SERVICE LETTER

No. 645

Piper Aircraft Corporation

Starter Vibrator Wiring Inspection

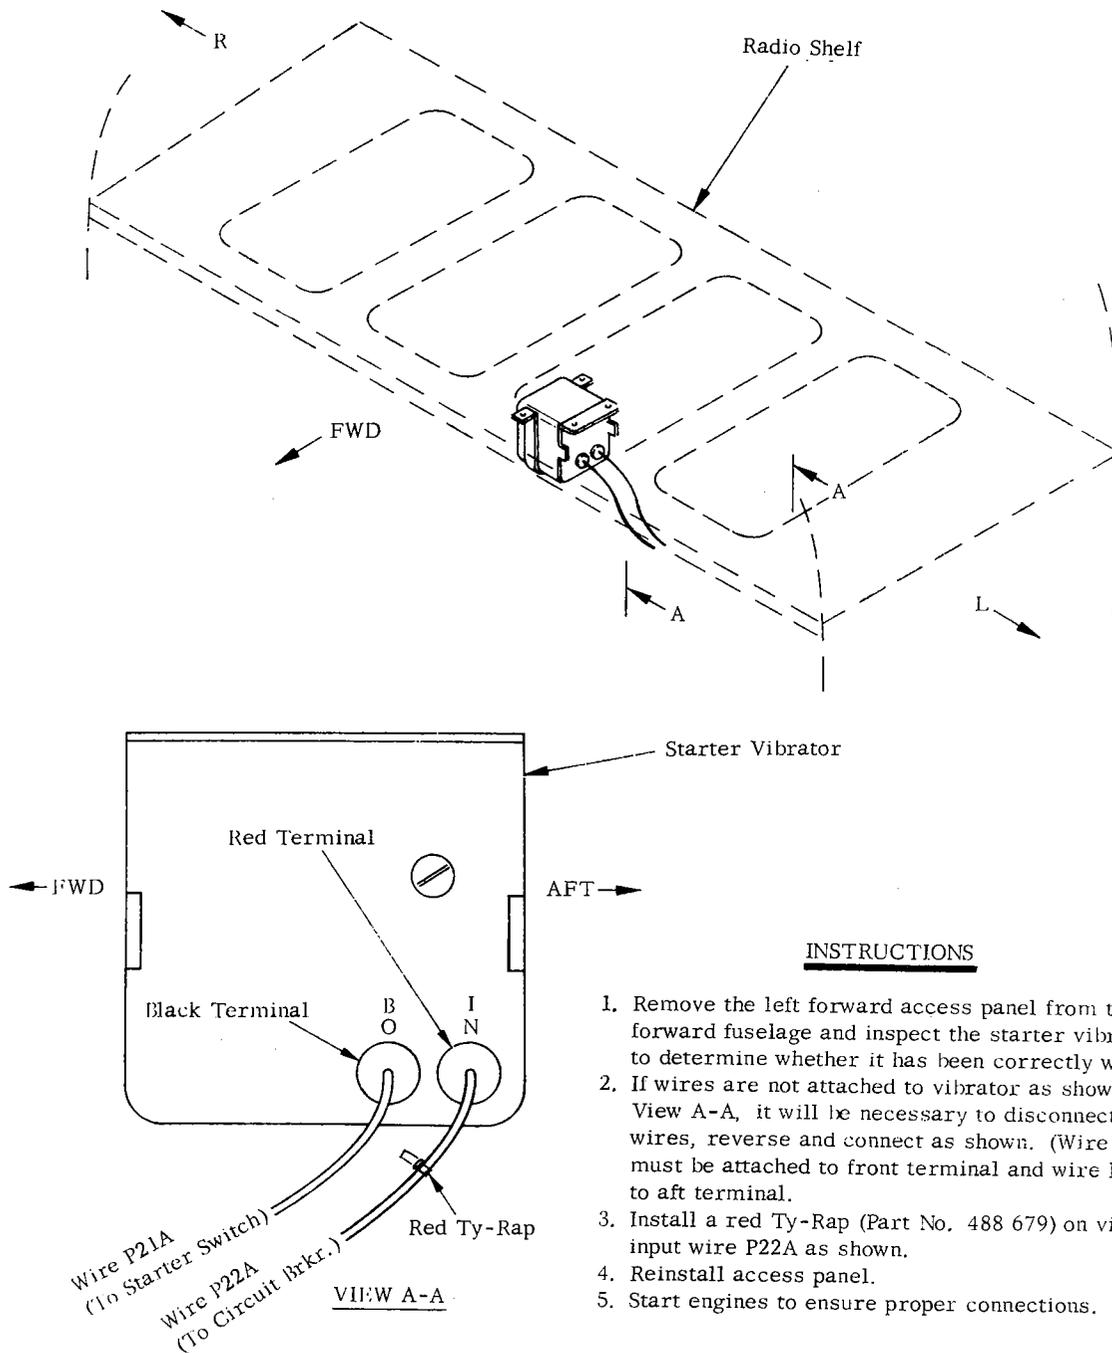
1. Remove the left forward access panel from the forward fuselage and inspect the starter vibrator to determine whether it has been correctly wired.
2. If wires are not attached to vibrator as shown on View A-A, it will be necessary to disconnect wires, reverse and connect as shown. (Wire P21A must be attached to front terminal and wire P22A to aft terminal.)
3. Install a red Ty-Rap (Part No. 488 679) on vibrator input wire P22A as shown.
4. Reinstall access panel.
5. Start engines to ensure proper connections.
